## **ADDENDUM NO. 1**

**DATE:** August 3, 2017  
**FROM:** City of Grand Junction Purchasing Division  
**TO:** All Offerors  
**RE:** Concrete Slab Construction for Streets Salt Shed IFB-4402-17-DH

SAND STORAGE BUILDING  
 GRAND JUNCTION, CO  
 DWG. NO. ABC.17.004  
 SHEET NO. 30

A1 CENTER ANCHORING PLAN VIEW 1" = 1'-0"

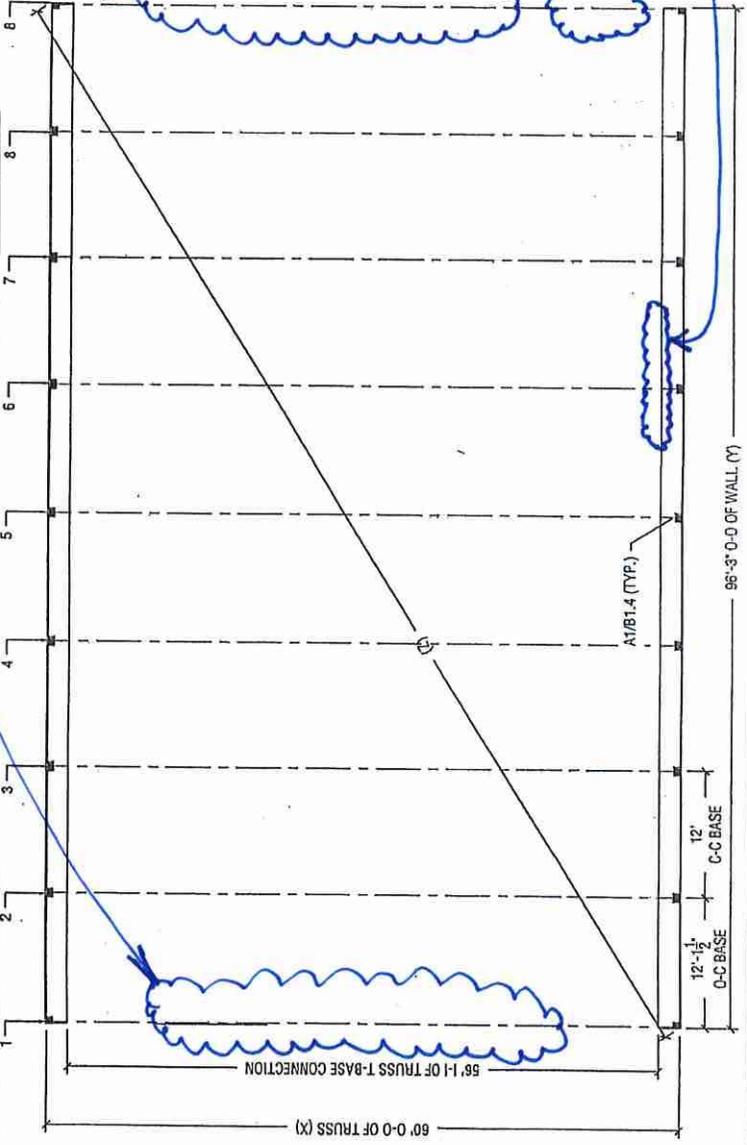
REFER TO SKETCH DETAIL FOR DOOR OPENINGS

REFER TO SKETCH DETAIL FOR SLAB TO BASE BLOCK WALL JOINT

## "DETAIL FOR DOOR OPENINGS"

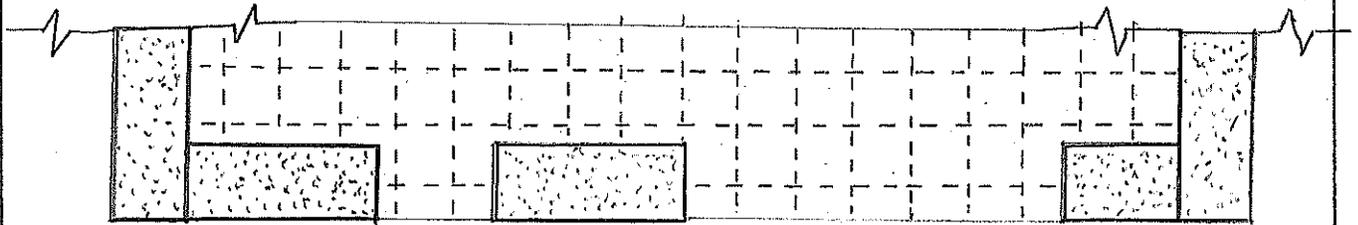
7. Requirements for the concrete and reinforcing steel layout in the area of the door openings was described at the site visit portion of the Pre-Bid conference. A sketched detail is being included in this Addenda.

1. EXTEND THE SLAB AND REIN. STEEL INTO DOOR OPENINGS TO THE OUTSIDE FACE OF THE BASE BLOCK WALLS.
2. MAINTAIN 2" COVER FROM BARS AND ALL SLAB EDGES.
3. SKETCH NOT TO SCALE
4. TYPICAL FOR ALL 3 DOOR OPENINGS

## "DETAIL FOR SLAB TO BASE BLOCK WALL JOINT"

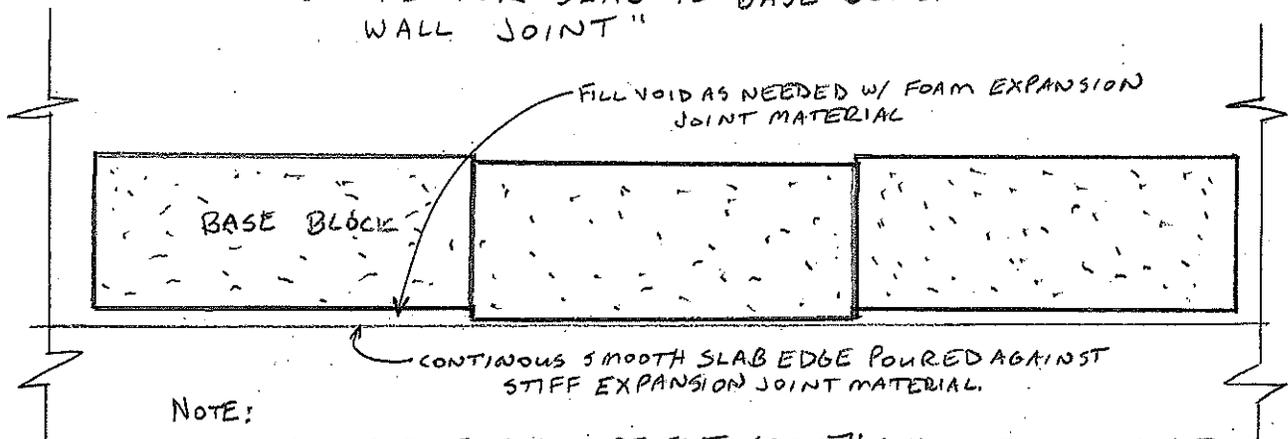
6. Requirements for the joint between the concrete slab and the concrete block base wall was described at the site visit portion of the Pre-Bid conference. A sketched detail is being included in this Addenda.

1. THE SLAB EDGE SHALL BE FLAT, SMOOTH AND NOT IN CONTACT WITH INDIVIDUAL BASE BLOCKS.
2. SLAB SHALL BE SEPARATED FROM BASE BLOCKS BY A  $\frac{1}{2}$ " THICK, STIFF EXPANSION JOINT MATERIAL THAT IS CONTINUOUS AND SMOOTH FOR THE FULL LENGTH.
3. ADDITIONAL FOAM EXPANSION JOINT MATERIAL SHALL BE PLACED BETWEEN THE STIFF MATERIAL AND THE BASE BLOCKS AS NEEDED TO COMPLETELY FILL ANY VOIDS CREATED BY OFFSETS BETWEEN BLOCK FACES OR OTHER BLOCK IMPERFECTIONS.
4. SKETCH NOT TO SCALE
5. TYPICAL FOR ENTIRE LENGTH OF JOINT
